CITY OF BLOOMINGTON

PLAN COMMISSION

October 10, 2022 5:30 p.m.

**BLOOMINGTON PLAN COMMISSION
STAFF REPORT
Location: 335 W. 8th Street**

SITE PLAN

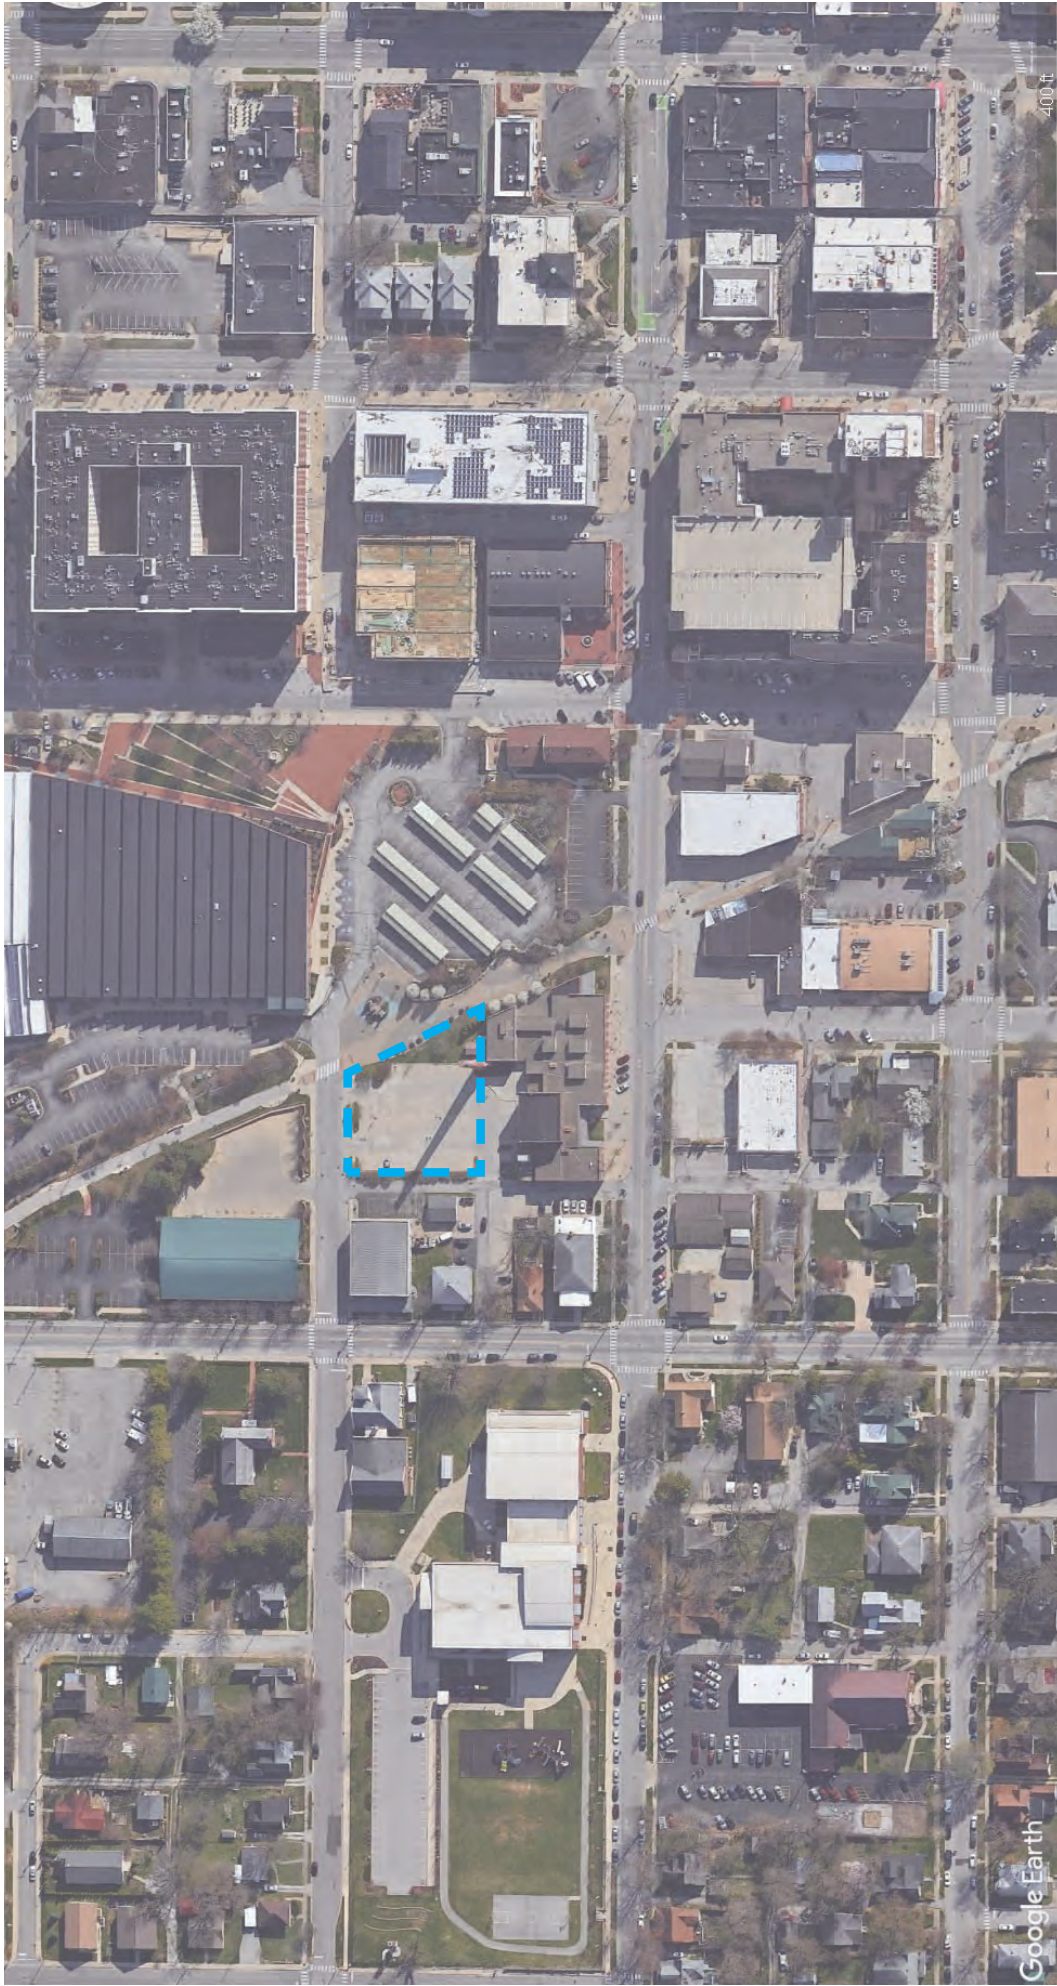
The Landscape Plan needs to be finalized with the grading permit. Some plant species will need to be changed (example is *Ulmus* x 'Frontier'), and the amount of pervious surface needs to be calculated to determine the quantity of interior plants.

1.) Revise the Landscape Plan prior to the Grading Permit issuance.
